Title - Sujet Food Service Bldg Westmorland Inst	
Solicitation No. - N° de l'invitation EC016-141832/A	Amendment No. - N° modif. 001
Client Reference No. - N° de référence du client EC016-141832	Date 2014-01-14
GETS Reference No. - N° de référence de SEAG PW-\$PWB-020-3350	
File No. - N° de dossier PWB-3-36100 (020)	CCC No./N° CCC - FMS No./N° VME
Solicitation Closes - L'invitation prend fin at - à 02:00 PM on - le 2014-01-23	Time Zone Fuseau horaire Atlantic Standard Time AST
F.O.B. - F.A.B. Plant-Usine: <input type="checkbox"/> Destination: <input type="checkbox"/> Other-Autre: <input type="checkbox"/>	
Address Enquiries to: - Adresser toutes questions à: Donovan, Janine PWB	Buyer Id - Id de l'acheteur pwb020
Telephone No. - N° de téléphone (506) 636-5347 ()	FAX No. - N° de FAX (506) 636-4376
Destination - of Goods, Services, and Construction: Destination - des biens, services et construction:

Addenda numéro 1

Public Works and Government Services Canada		Travaux publics et Services gouvernementaux Canada		Drawing title Titre du dessin		designed G.LUMMIS		conçu		date	
project NEW FOOD SERVICE BUILDING, WESTMORLAND INSTITUTION project				CHANGES TO RM.125 FOOD SERVICE EQUIPMENT L

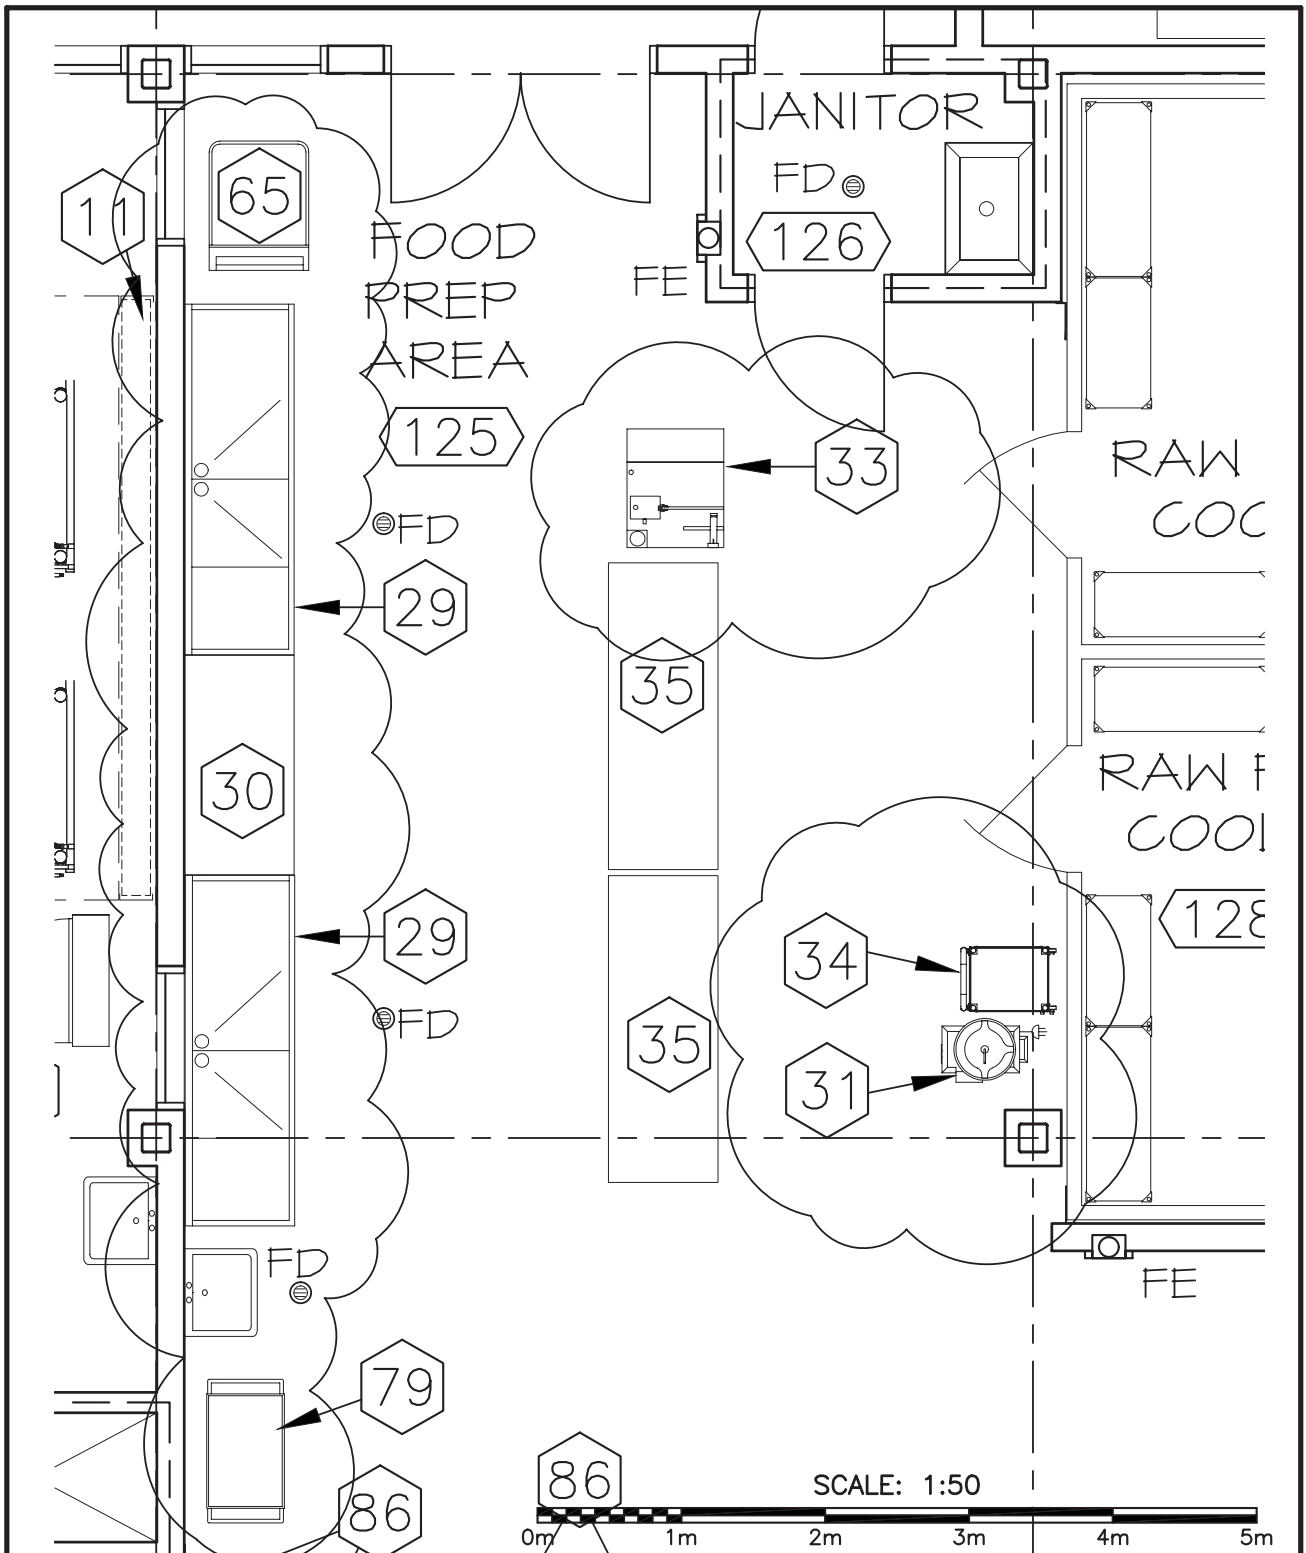
.1 Quantity: revise from 1 to 2. Refer to attached sketch layout FSK-01.

1. **DRAWING FS.2 - GROUND FLOOR EQUIPMENT LAYOUT**

- .1 Change equipment layout in Food Prep Area (125) as indicated on sketch FS SK-01 (attached).
- .1 Add 1 additional item # 29 as shown.
- .2 Relocate the following items as shown on sketch FS SK-01 (attached).
- .1 Item #31 Vegetable processor
Services: 10 Amp - 208 v - 1 phase outlet on wall.
Floor drain.
- .2 Item #33 Vacuum clipper w/nozzle
Services: Verify with Owner.
6 amp - 208 volt - 1 phase electric outlet on wall.
Compressed air inlet.

| .3 | Item #34 | Cart for Vegetable Processor |
| .4 | Item #65 | Garbage container |
| .5 | Item #79 | Stainless steel utility cart |
